ECE/TRANS/WP.29/GRSG/2006/10
9 February 2006

PROPOSAL FOR DRAFT AMENDMENTS TO REGULATION No. 107

(M₂ and M₃ vehicles)

Transmitted by the expert from Germany

Figure 1

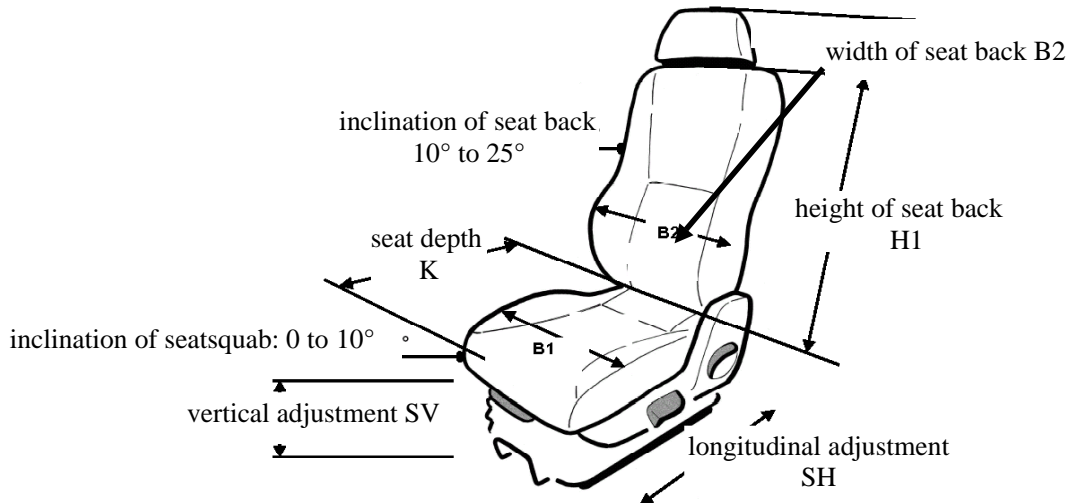
2.1.1. The width of the seat squab shall be at least 450 mm for a length of 200 mm (dimension B1 of figure 1).

2.1.2. The width of the seat back shall be at least 480 mm in one position measured in the lower half of the seat back (dimension B2 of figure 1).

The depth of the seat squab shall be at least 420 mm, measured in the median longitudinal vertical plane (dimension K of figure 1).

The height of the seat back shall be at least 500 mm, measured in the median longitudinal vertical plane (dimension H1 of figure 1).

The vertical adjustment range shall be at least 100 mm for vehicles of category M₃ (dimension SV of figure 1). In case of vehicles of category M₂ this figure shall be 60 mm.

The longitudinal adjustment range shall be at least 180 mm (dimension SH of figure 1).

Figure 2

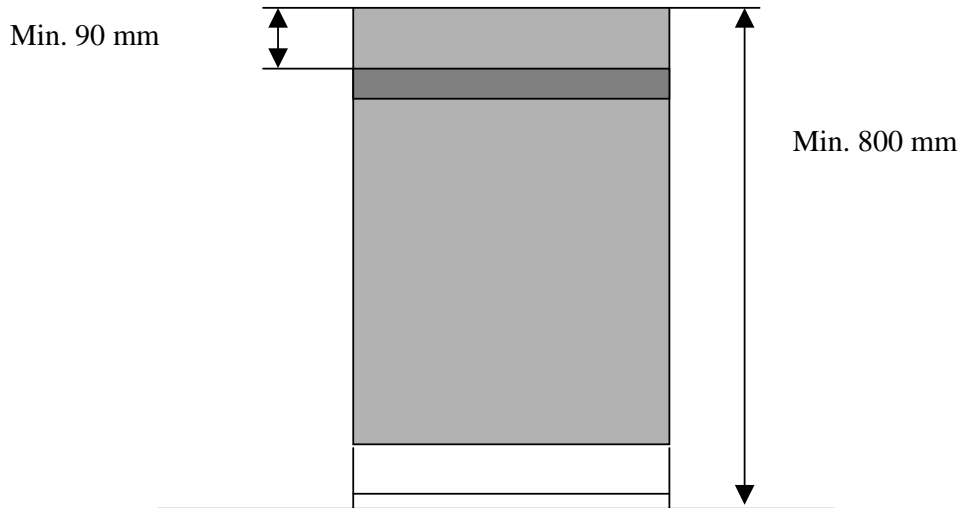
3.1.1. The height of the partition or barrier shall equal at least 800 mm measured from the floor of the passenger compartment (see figure 2).

3.1.4. The distance between the most upper edge of an area destined to hold any object, e.g. tables, etc. and the most upper edge of a partition or barrier shall be at least 90 mm (see figure 2).
